## PUBLIC IMPROVEMENT CONSTRUCTION PLANS

PUBLIC IMPROVEMENT CONSTRUCTION PLANS  
WOODMEN FRONTAGE RD. TURN LANE  
FOR  
CHALLENGER COMMUNITIES, LLC  
BENTGRASS MEADOW DR. & WOODMEN FRONTAGE RD.  
FALCON, CO 80831 EL PASO COUNTY

# CD\_V3.pdf Markup Summary 5-17-2022

TYPICAL SECTION – WOODMEN FRONTAGE ROAD (LEFT TURN LANE)

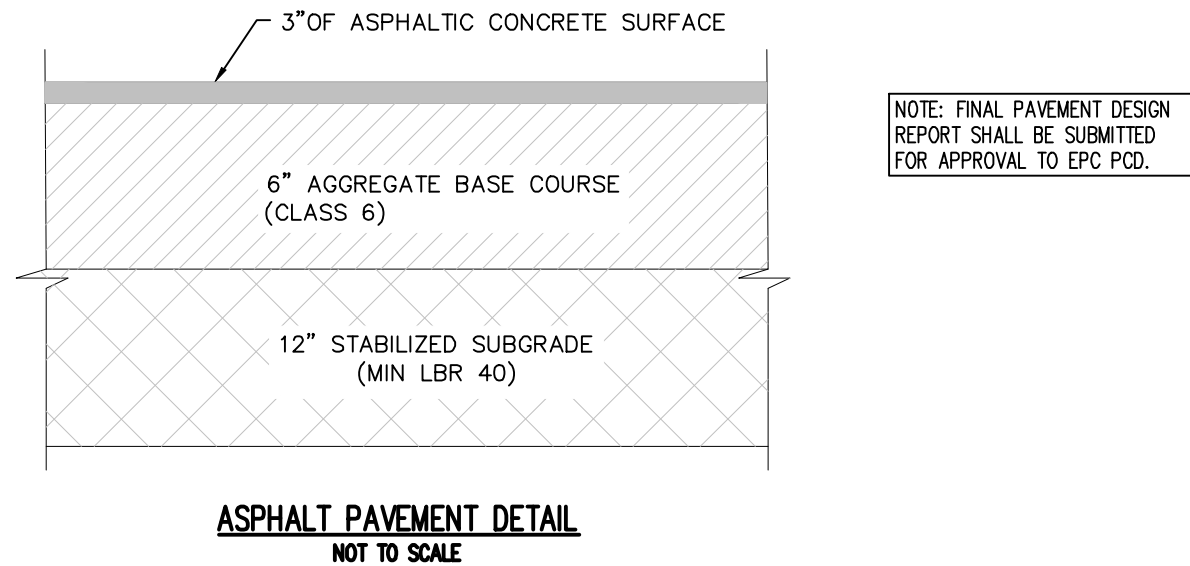
Include detail for roadside swales  
or show it here on typical section

Added detail to the typical section.

**DETAIL GRADING PLAN**

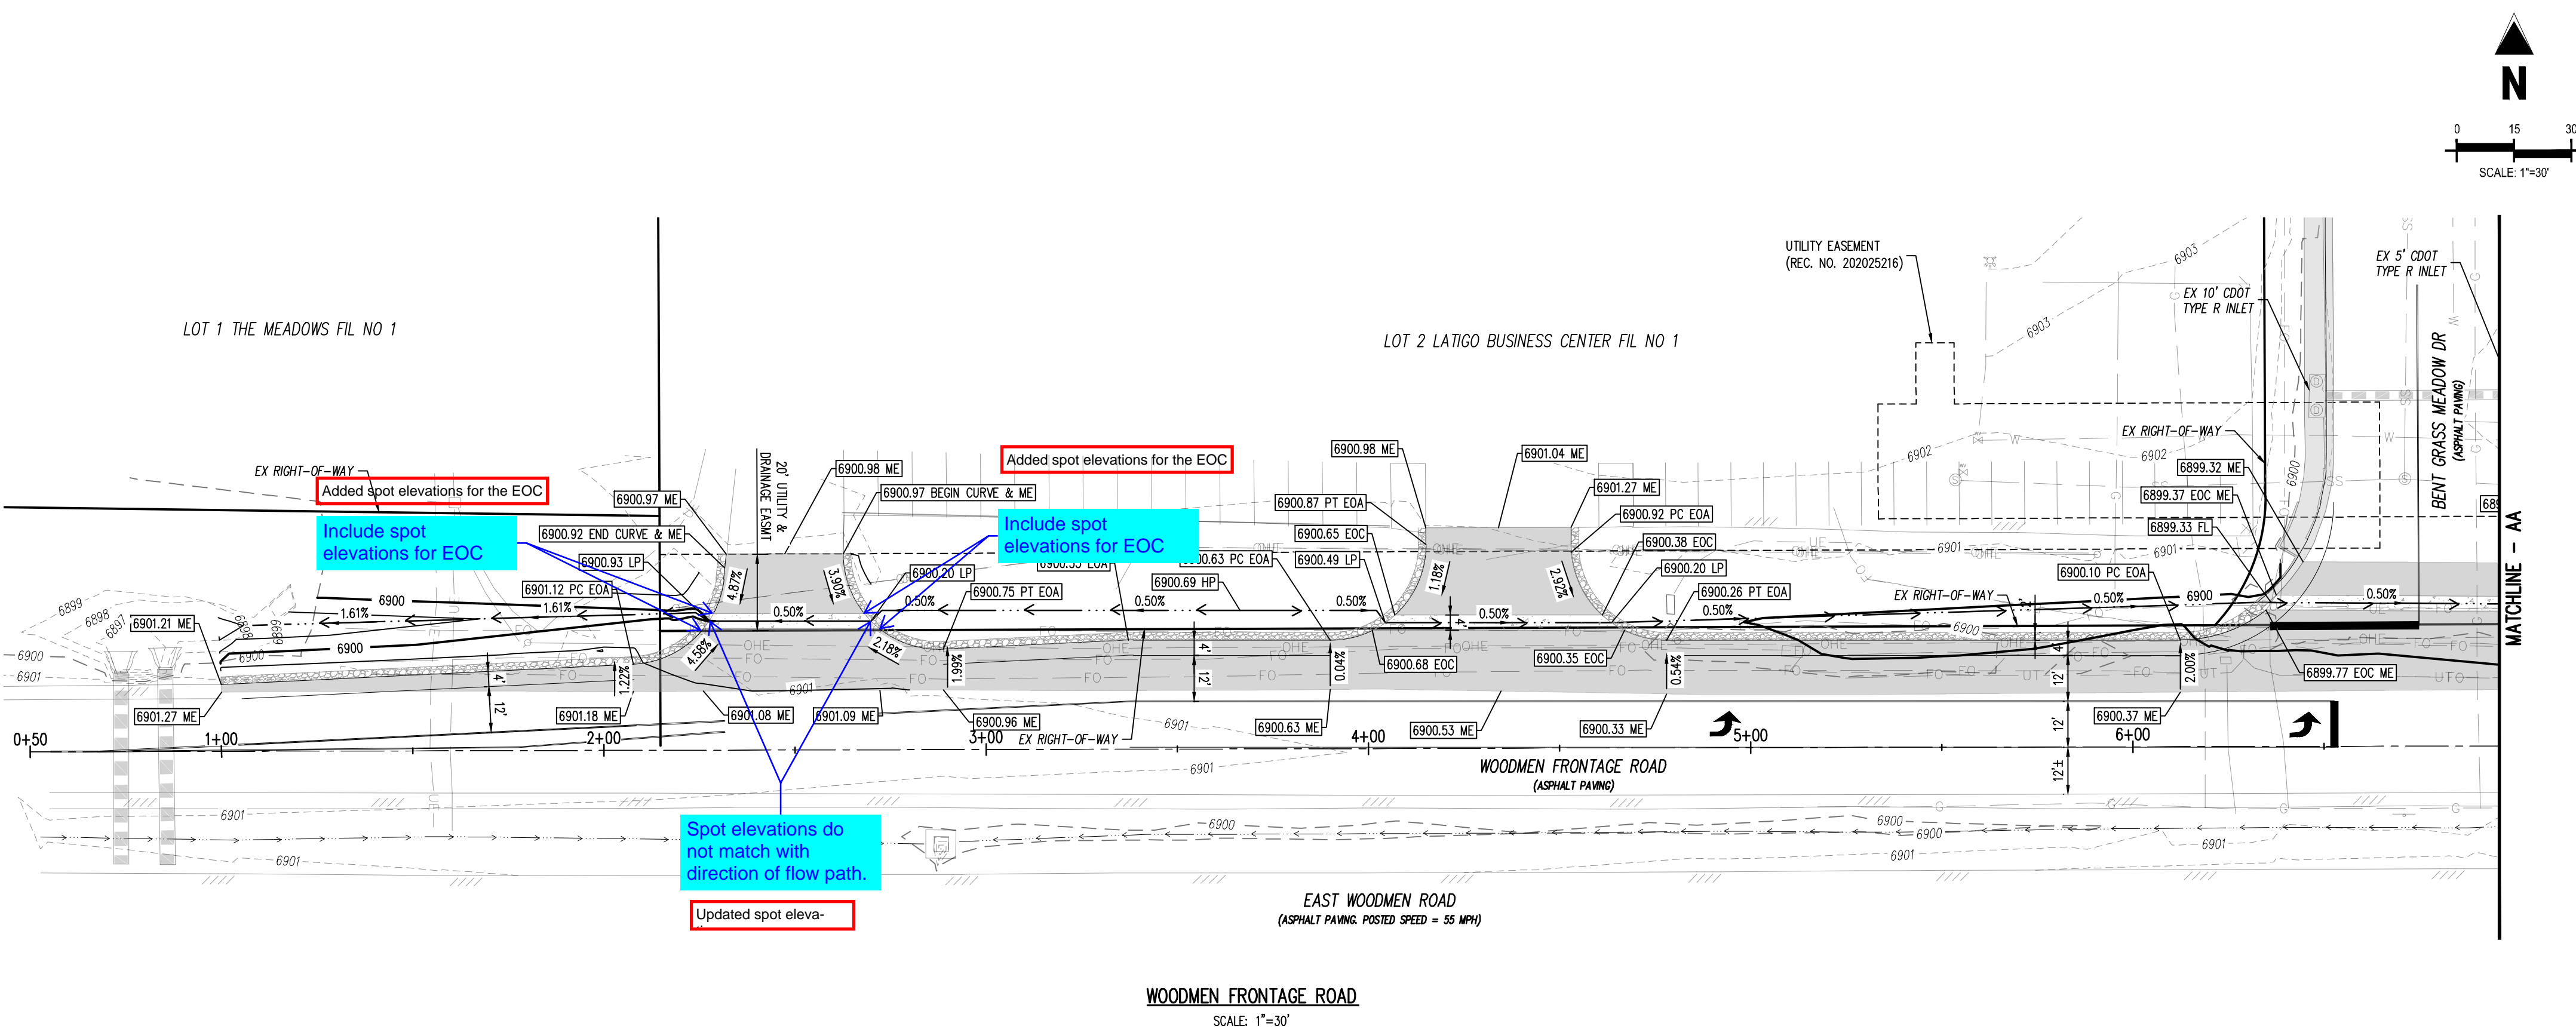
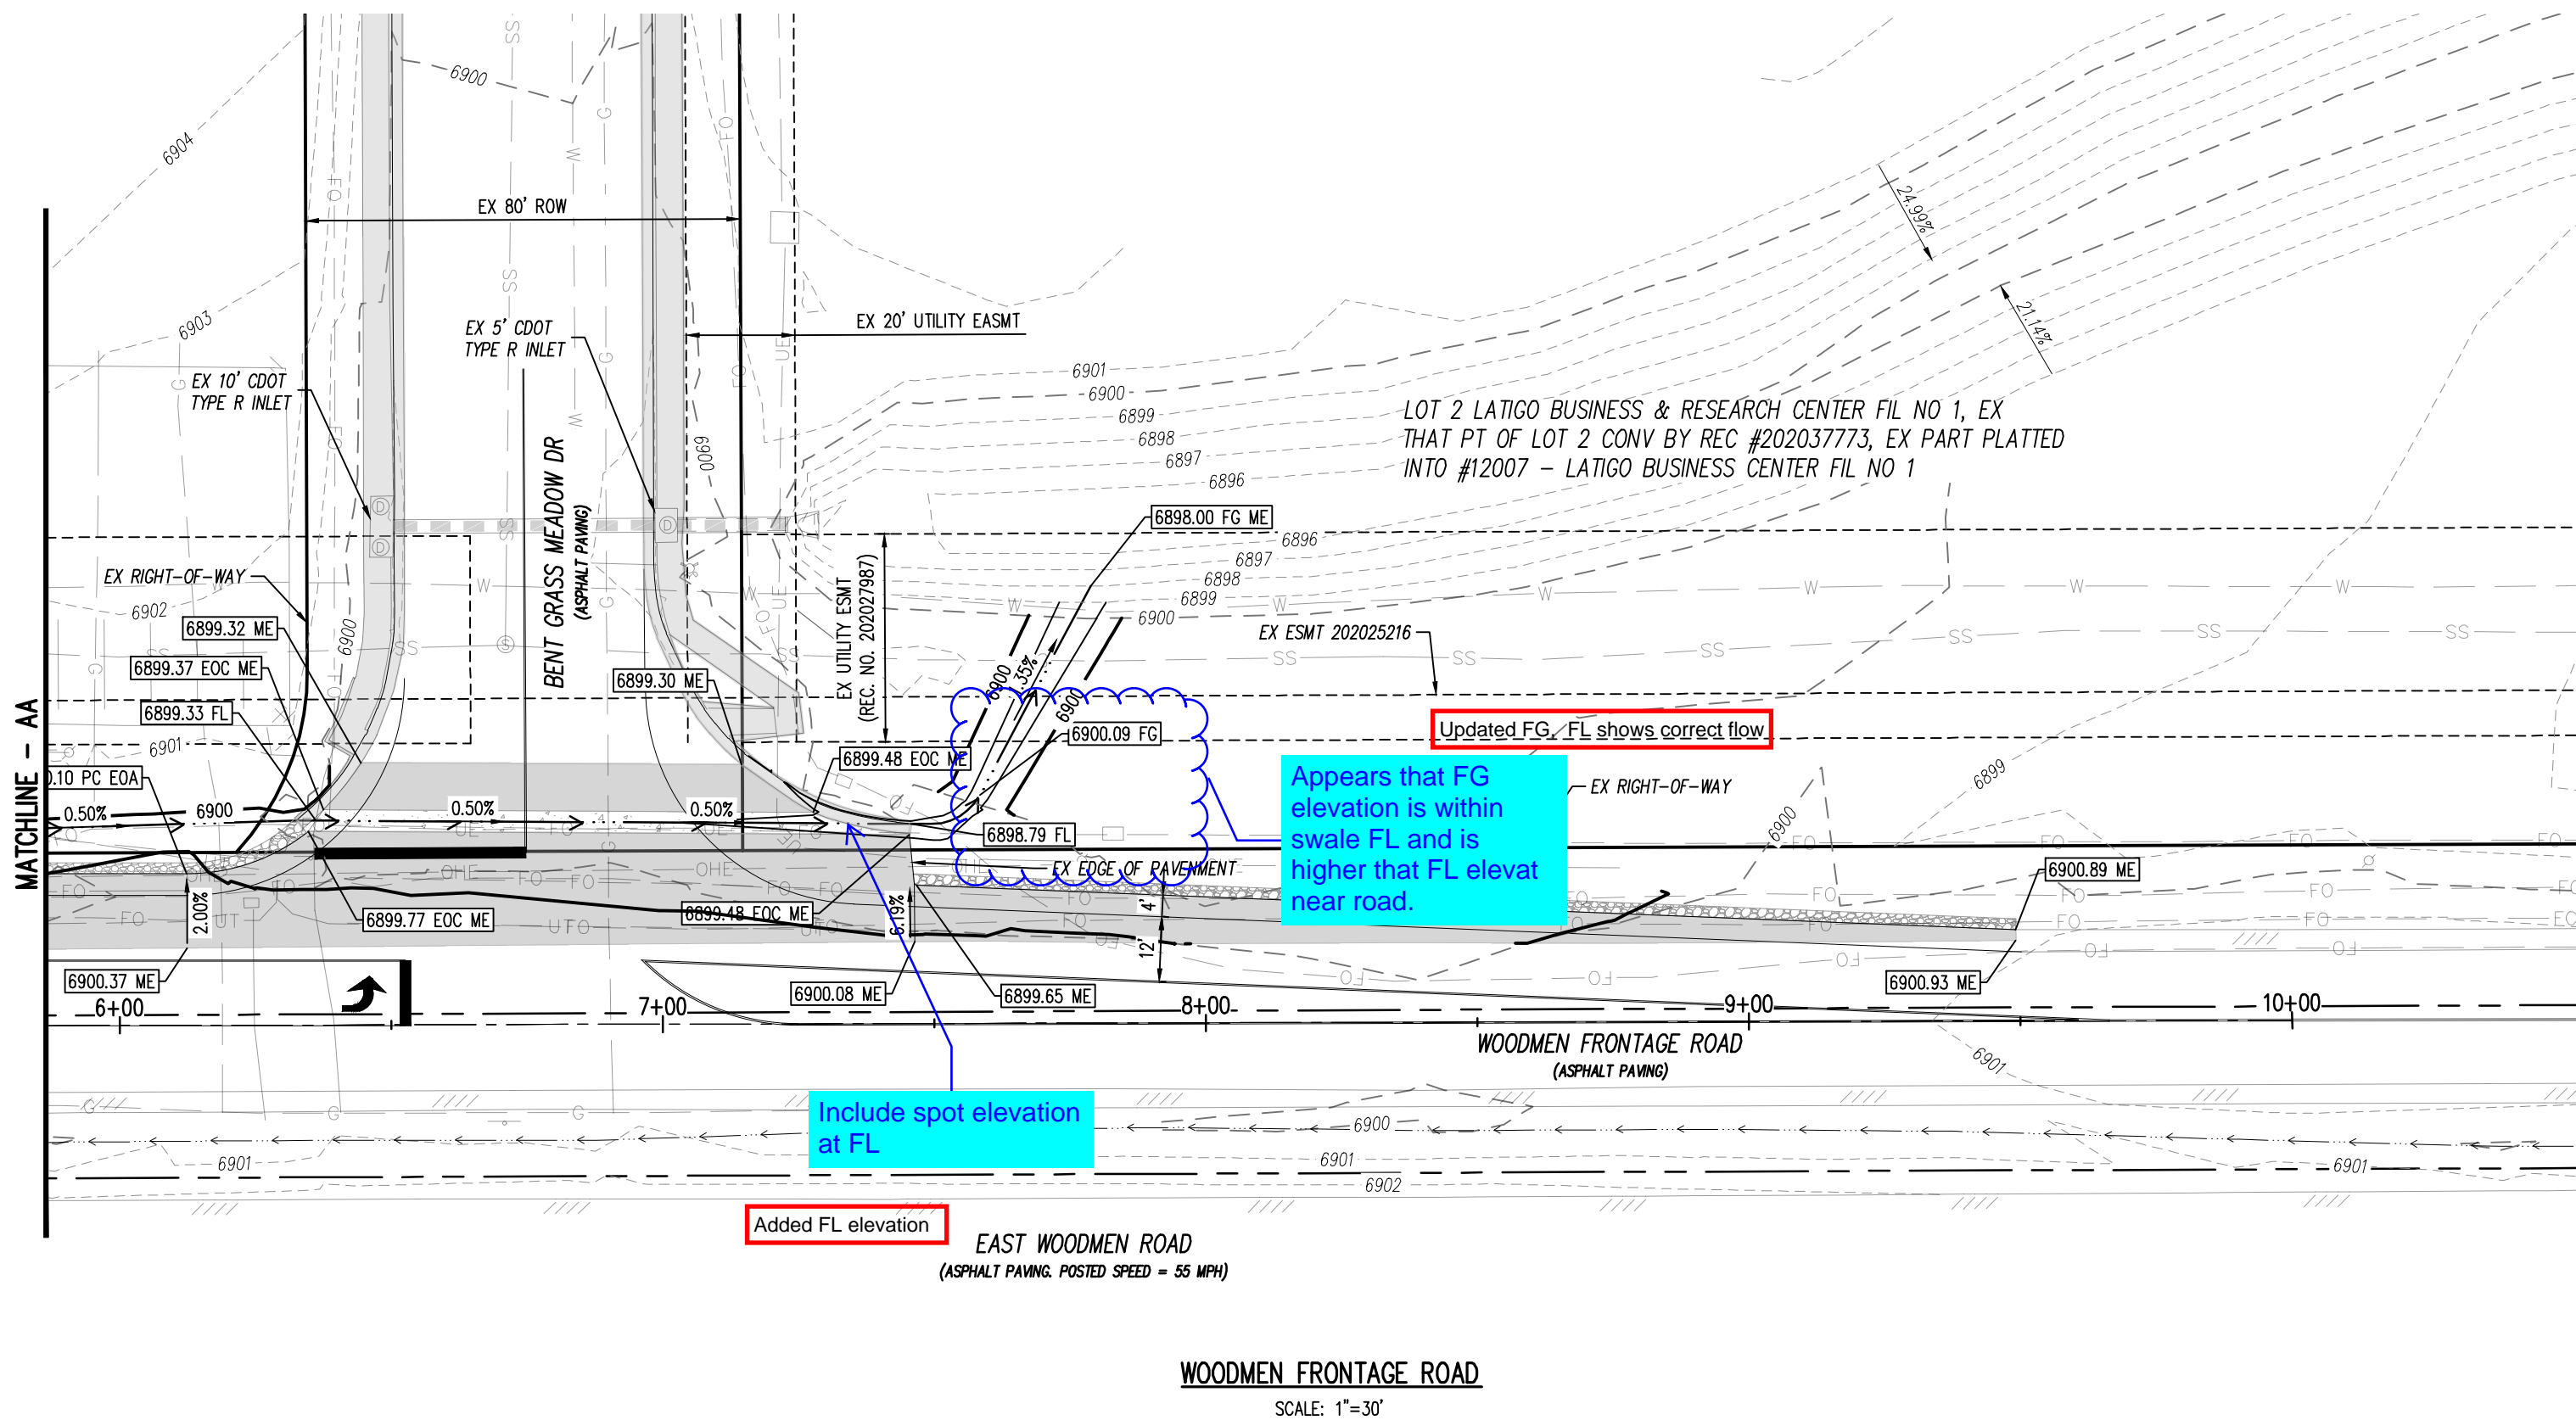
Spot elevations do not match with direction of flow  
path.

Include spot elevations for EOC

Include spot elevations for EOC

Include spot elevation at FL

Appears that FG elevation is within swale FL and is higher than FL elevation near road.

Updated FG, FL shows correct flow

Added spot elevations for the EOC

Added spot elevations for the EOC

Added FL elevation

Updated FG, FL shows correct flow

## STREET IMPROVEMENT SECTIONS

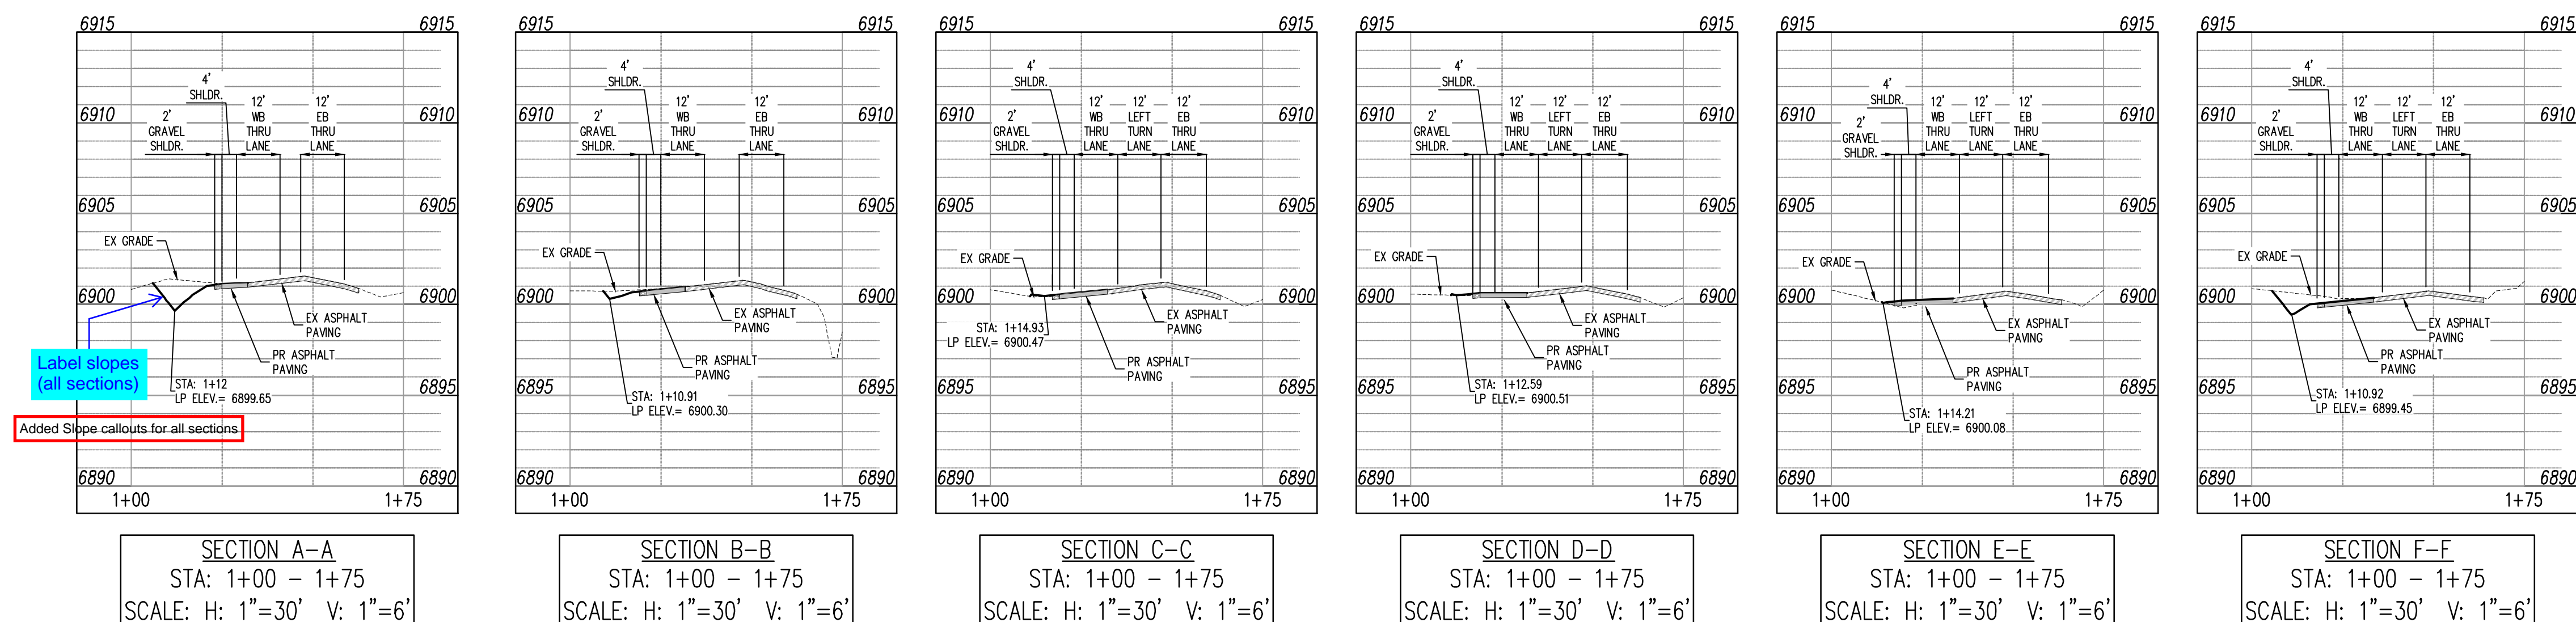
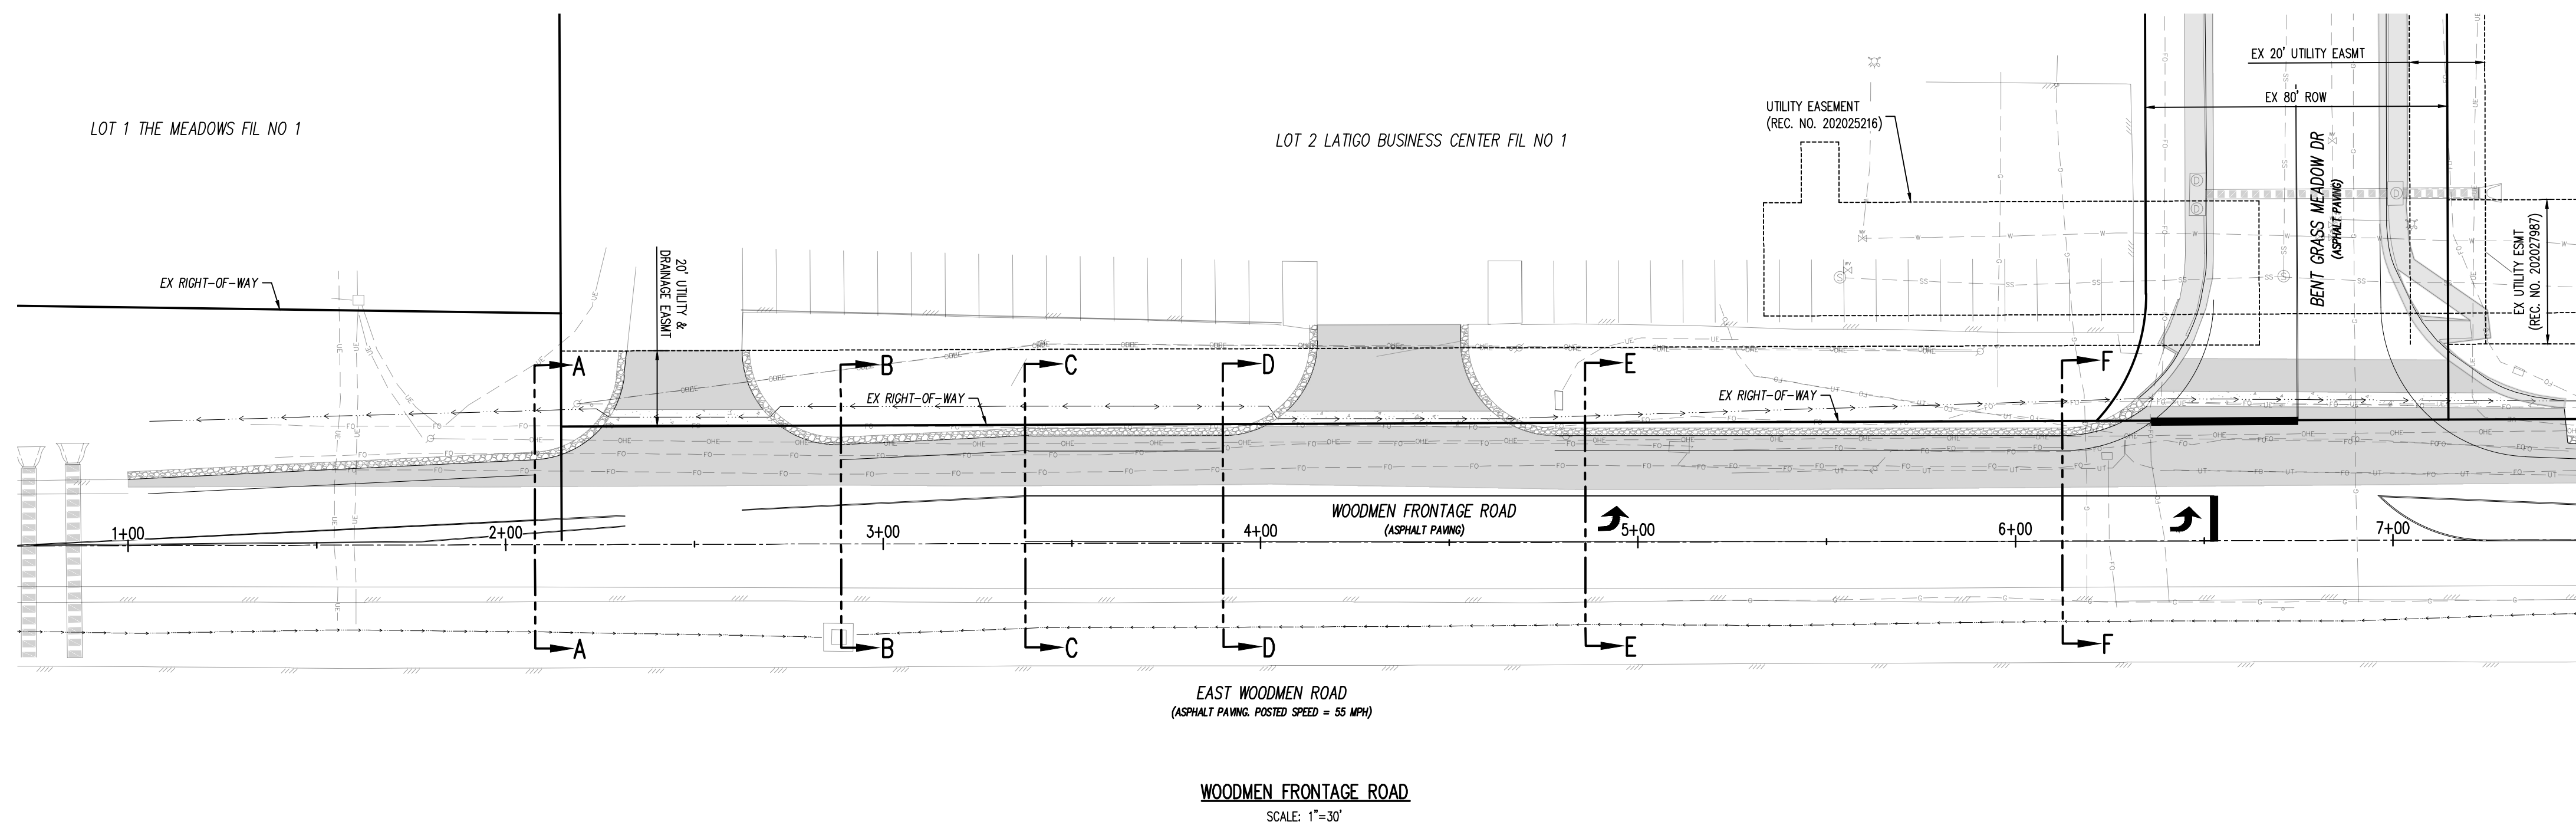
Label slopes (all sections)

Added Slope callouts for all sections
